STAFF REPORT
COMMUNITY DEVELOPMENT DEPARTMENT

HEARING DATE: 3/23/2021
 TO: Mayor & City Council
 FROM: Joe Dodson, Associate Planner
 208-884-5533
 SUBJECT: H-2020-0100
 Compass Pointe Subdivision
 LOCATION: The site is located at 3247 S. Locust Grove Road, in the NE ¼ of the NE ¼ of Section 30, Township 3N., Range 1E.

C. Landscape Plan (dated: 11/2/2020/1/21/2021 2/18/2021) **NOT APPROVED**

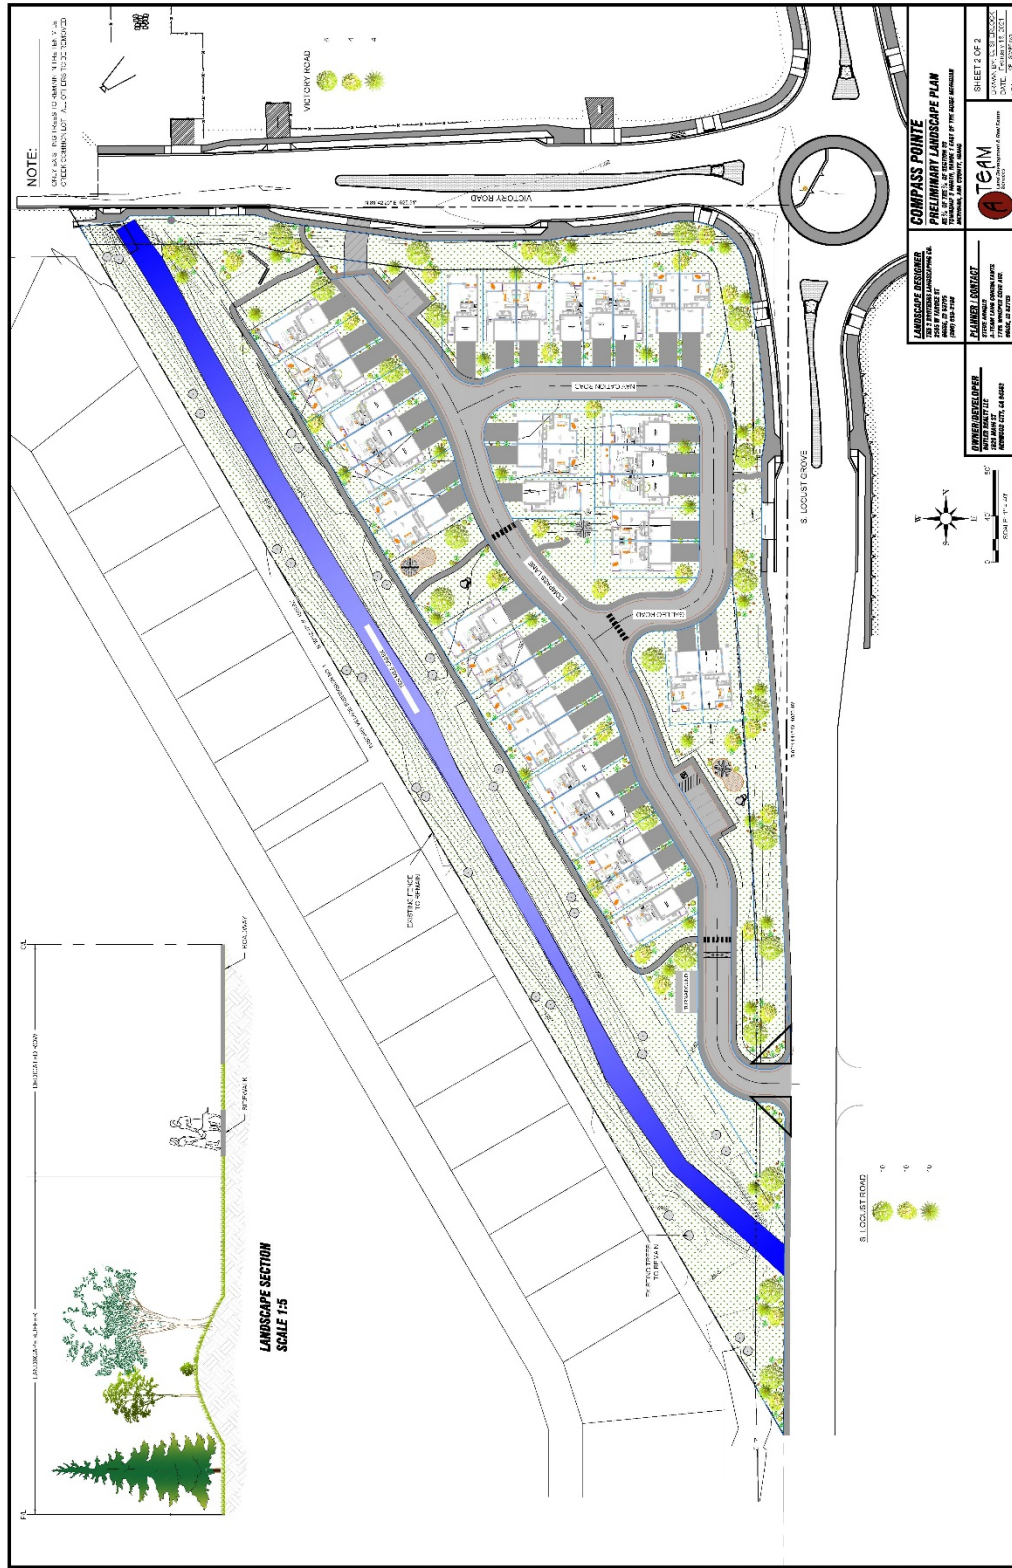
The submitted landscape plan and preliminary plat depict a 25-foot wide landscape buffer; the correct number of trees appear to be shown on the submitted landscape plans (see Section VIII.C). However, there is no landscape calculations table as required by code. The Applicant shall be required to submit revised plans that include a calculation table depicting the linear footage of the landscape buffers, the required number of trees, their common name and their scientific name, the class of tree, and the dimensions of the tree canopy at maturity; each type of shrub proposed to be used should also be included in the calculations table.

Common open space is required to be landscaped in accord with the standards listed in UDC 11-3G-3E. The total square footage of common open space **is not** included because there is no Landscape Calculations table on the submitted landscape plans demonstrating compliance with UDC standards. However, Staff can graphically see that the open space lots are vegetated according to UDC standards. Still, the Applicant will be required to add a calculations table with the recommendation noted above and revise the landscape plan to show the addition of the new between Lots 2-14, Block 2 as recommended by Staff.

The proposed pathway located behind the homes and adjacent to the Tenmile Creek is also required to be landscaped with a tree every 100 feet per UDC 11-3B-12. However, the Applicant did not include a 5-foot wide landscape bed on either side meant for the required trees. The Applicant will need work with the irrigation district to obtain a license agreement to include at least 5 feet of landscaping on one side of this pathway. Otherwise, the Applicant will need to apply for Alternative Compliance with the Final Plat submittal so show an equal or better means of compliance with this requirement.

All fencing is required to comply with the standards listed in UDC 11-3A-7. Fencing is shown on the landscape plan along the subdivision boundary and around the central open space lot along the western portion of the site but no other fencing is shown. Fencing shown next to any open space shall be open-vision or semi-private fencing per UDC requirements.

- b. Show open vision fencing on the west side of the pathway abutting the Tenmile Creek; all fencing shall comply with the standards listed in UDC 11-3A-7.

- e. Show the required landscaping on the western side of the pathway abutting the Tenmile Creek per UDC 11-3B-12.
 5. ~~At least ten (10) days prior to the City Council hearing, the open space exhibit included in Section VIII.D shall be revised to accurately depict and label the qualified and non-qualified open space per the standards in UDC 11-3G-3 and per the revisions recommended by Staff.~~

D. Open Space Exhibit (dated: 11/02/2020/11/21/2021-2/18/2021) **NOT APPROVED**

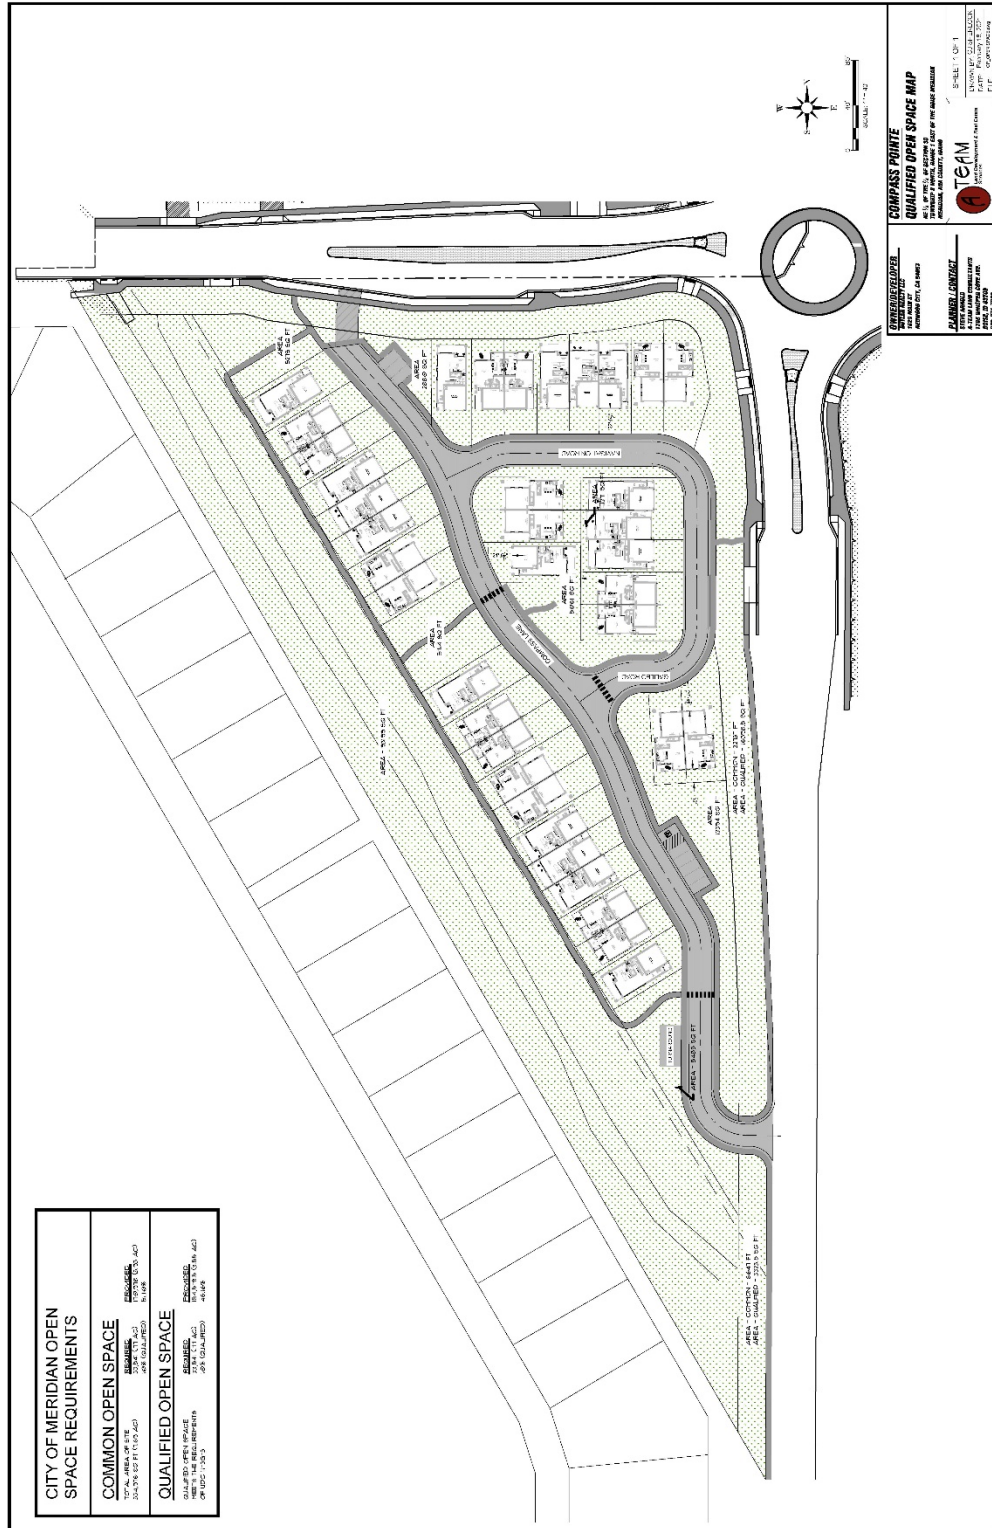
A minimum of 10% **qualified** open space meeting the standards listed in UDC 11-3G-3B is required. According to the property size of 7.69 acres, the Applicant should supply at least 0.77 acres of qualified open space, or approximately 33,500 square feet. The applicant is proposing 3.2891 acres of open space, of which ~~2.84~~ 3.4 acres is shown as qualifying open space on the ~~submitted~~ revised open space exhibit (see Section VIII.D).

Some of the area listed as qualifying open space by the Applicant does not meet UDC standards due to their size not being at least 5,000 square feet or being near the 50' x 100' dimensions. Once this area is removed, the qualified open space proposed is 2.6897 acres, ~~down from 2.84~~; the Applicant should revise the open space exhibit to correctly label the qualified open space by removing Lot 23, Block 1, Lot 1, Block 2, Lot 4, Block 3, and Lot 3 Block 4. More importantly, the
